THE PORT AUTHORITY OF NY & NJ

ADDENDUM #6

**TO PROSPECTIVE BIDDER(S) ON CONTRACT # WTCR – W30-2011-31
WTC REDEVELOPMENT – WTC TOWER 2 PLAZA INTERIM IMPROVEMENTS**

SECTION THROUGH RAISED SLAB

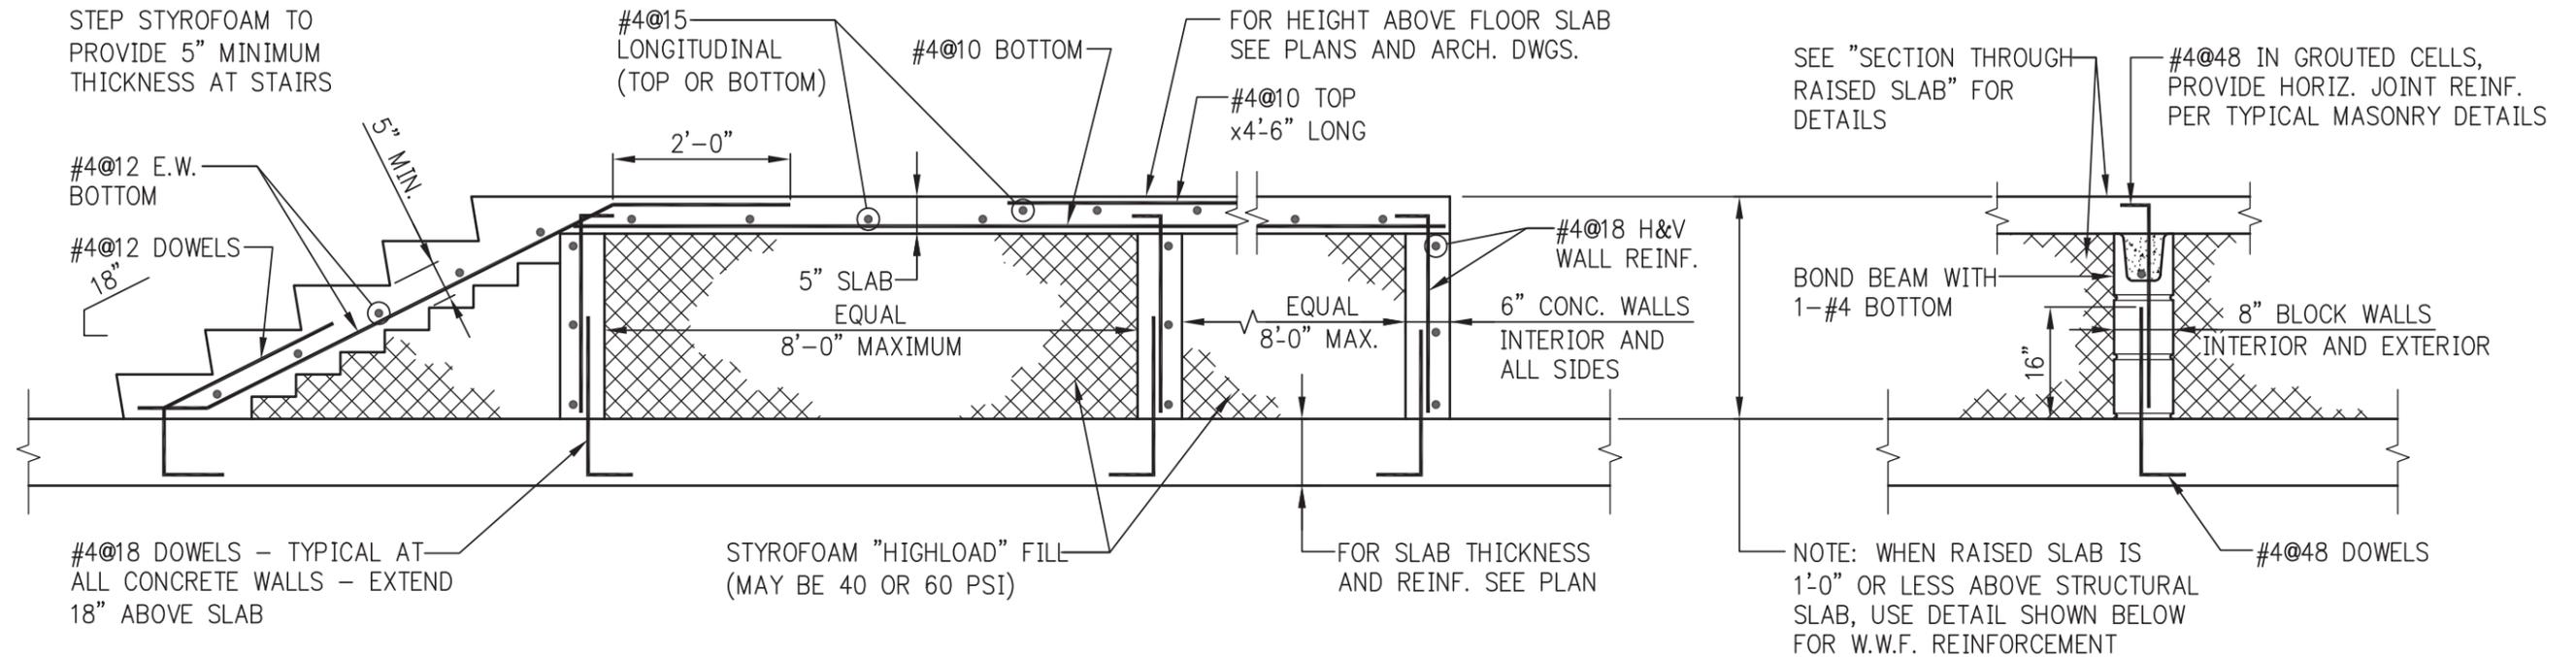
Question #145	<p>Addendum No 2, SK-9. (Sheet 3 of 3), at “SECTION THROUGH RAISED SLAB”, left hand side shows a stairway with 5 risers. Is this stairway in this contract? If so, is a handrail required?</p>

Question #146	Addendum No 2, SK-9. (Sheet 3 of 3), at “SECTION THROUGH RAISED SLAB”, at the bottom left of the Section shows “ #4 DOWELS – TYPICAL AT ALL CONCRETE WALLS – EXTEND 18” ABOVE SLAB.” We have to assume these dowels are existing in place. Would that be correct?

Question #147	Addendum No 2, SK-9. (Sheet 3 of 3), at “SECTION THROUGH RAISED SLAB”, at the bottom right of the Section shows “FOR SLAB THICKNESS AND REINF. SEE PLAN.” We assume this slab is also in place and existing. Correct?

Question #151	Addendum No 2, SK-9 (Sheet 3 of 3), shows a “SECTION THROUGH RAISED SLAB”. At the top of the section there are designations for the various rebar sizes and placements. Addendum No 2, SK-2A shows a completely different rebar sizes and placements. We are

Answer #145	<p>There are no stairs or handrails in the Contract. SK-9 indicates the current as built condition adjacent to the Tower 2 structure, for the purposes of defining demolition scope. The Raised slab, knee walls and built-up assembly shall all be demolished down to the existing structural slab.</p>

Answer #146	SK-9 indicates the current as built condition adjacent to the Tower 2 structure, for the purposes of defining demolition scope. The Raised slab, knee walls, and build-up assembly shall all be demolished down to the existing structural slab. Existing waterproofing membrane shall not be disturbed and shall remain in place. Cut dowels down to existing slab.

Answer #147	SK-9 indicates the current as built condition adjacent to the Tower 2 structure, for the purposes of defining demolition scope. The Raised slab, knee walls, and built-up assembly shall all be demolished down to the existing structural slab.

confused, please help to clarify.
Answer #151	Any areas of new raised slab on Styrofoam shall follow the typical raised slab construction detail shown in SK-16 for the purpose of slab thickness, knee wall sizes and rebar requirements.

Tower 2 Plaza Interim Improvements
Existing Grade Elevations
SK-15
2/25/2015

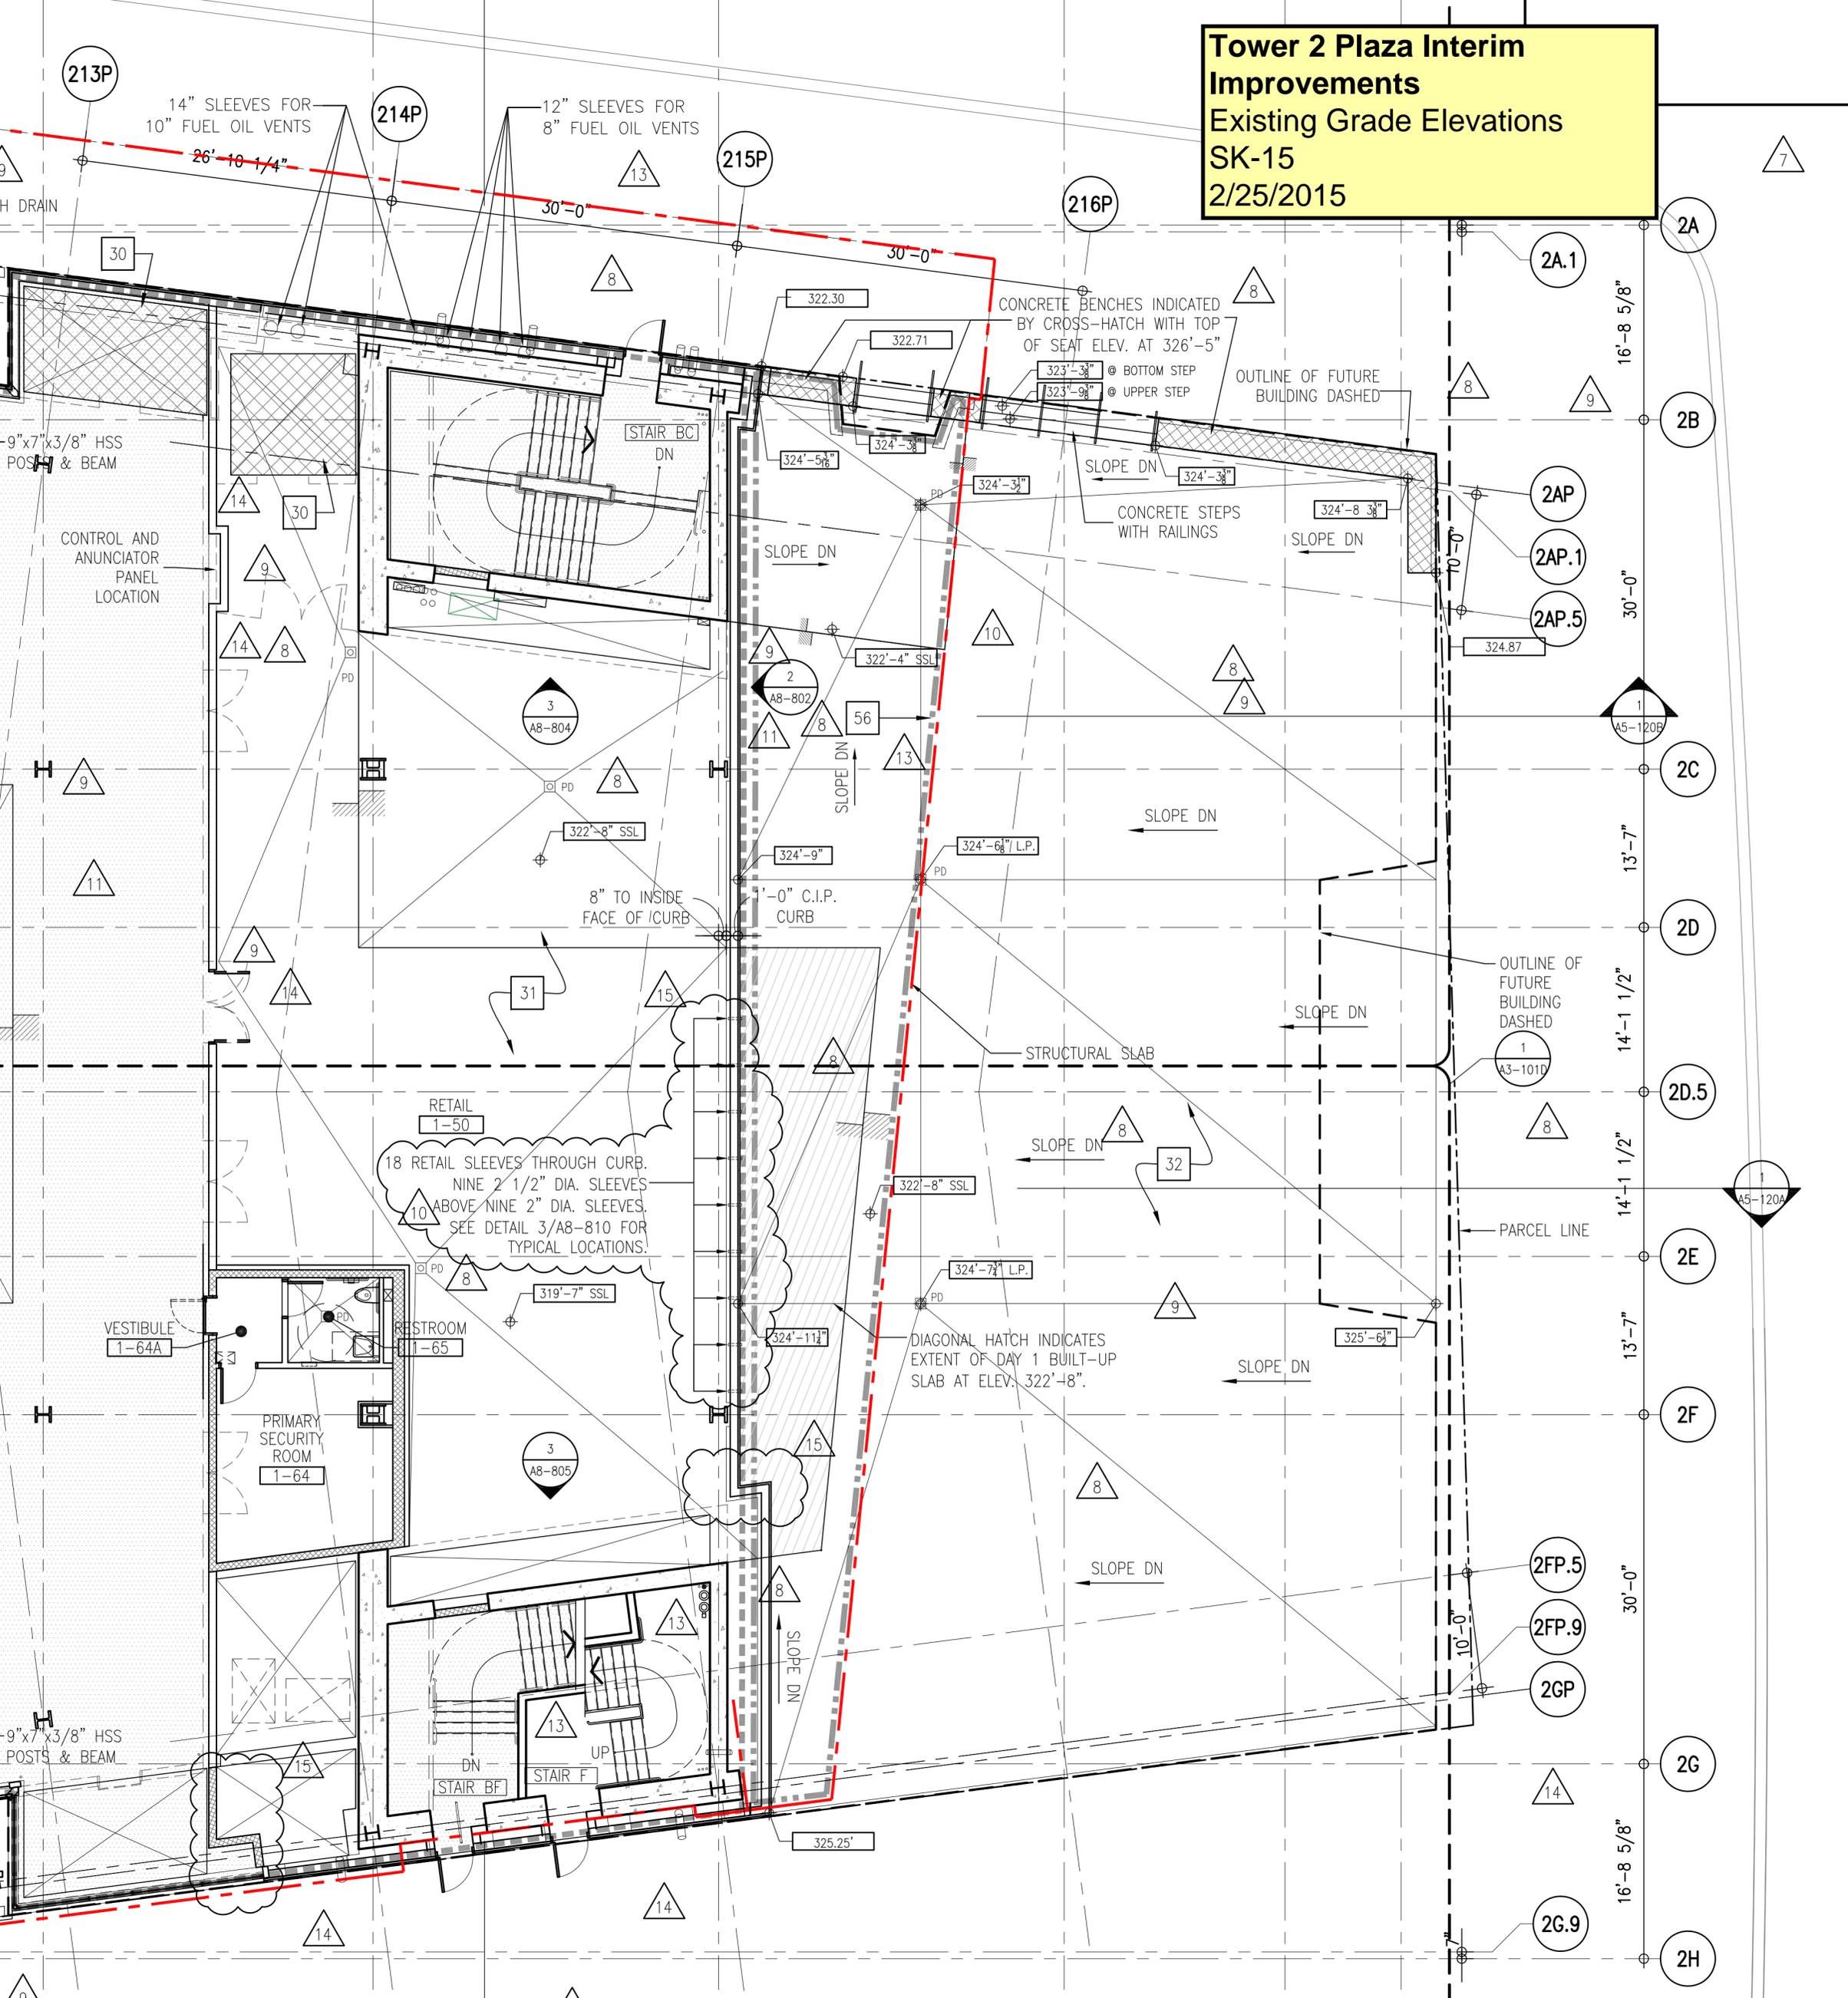
Answer #140	Contractor to include a ½” expansion joint around the column so the column and concrete do not touch.
Question #141	RE: Detail 2 and 3 / L-02 - Please provide elevations for the existing structural deck and existing depressed structural deck so that the quantity of foam fill can be calculated.

Answer #141	The existing elevation of the structural slab is 322'-8"; it steps down to 322'-4" at the North. Also refer to SK-15.
Question #142	<p>Addendum No 2, Question #4 asks for “Sheet L-02 – please provide greater detail as to what we are required to demolish (i.e. 6” reinforced concrete or 3” asphalt, etc.). Please also provide dimensions...”</p> <p>Answer #4 responds “Refer to attached Sketches SK-7, SK-8, & SK-9 dated 2/10/15, pertaining to the area between the slurry wall and the face of the building.</p> <p>For all other areas the Contractor is to assume existing 6” layer of crushed stone and soil.”</p>
